## Proposal for the 05 series of amendments to UN Regulation No. 78 (Motorcycle braking)

### Submitted by the Working Party on Automated/autonomous and Connected Vehicles\*

The text reproduced below was adopted by the Working Party on Automated/autonomous and Connected Vehicles (GRVA) at its fifth session, in February 2020 (see ECE/TRANS/WP.29/GRVA/5, para. 75). It is based on ECE/TRANS/WP.29/GRVA/2020/15. It is submitted to World Forum for Harmonization of Vehicle Regulations (WP.29) and the Administrative Committee of the 1958 Agreement (AC.1) for consideration and vote at their June 2020 sessions.

**Model B**

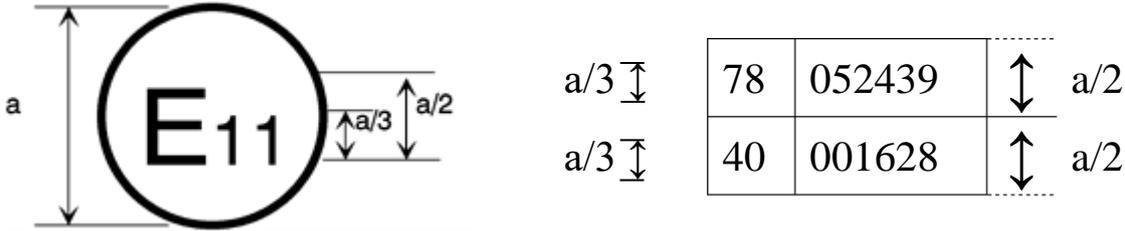
*Annex 2, amend to read:*

The above approval mark affixed to a vehicle shows that the vehicle type concerned has been approved in the United Kingdom (E 11) pursuant to UN Regulations Nos. 78 and 40. The first two digits of the approval numbers indicate that, at the dates when the respective approvals were granted, UN Regulation No. 78 included the 05 series of amendments but UN Regulation No. 40 was still in its original form.
